This letter is to clarify the screening requirements for landfill sites as related to County Highway CE and the Lehrer Sanitary Landfill.

SND
OUTAGAMIE CO.

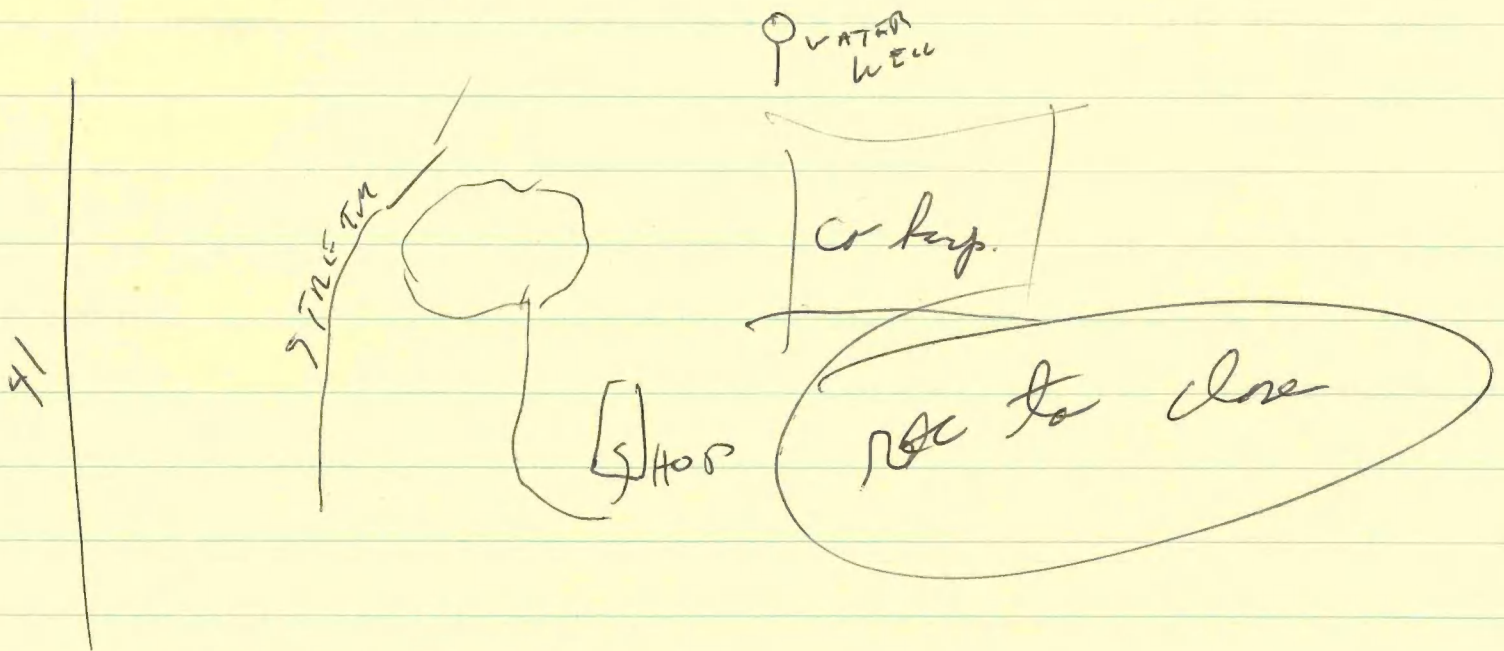
what dispose of: roadside litter

Dept of Trans permission?

- X small creek 10 ft away.
- X Hospital within ⁸⁰⁰ 1/2 mile well at hosp.
Highway about 1000 ft.
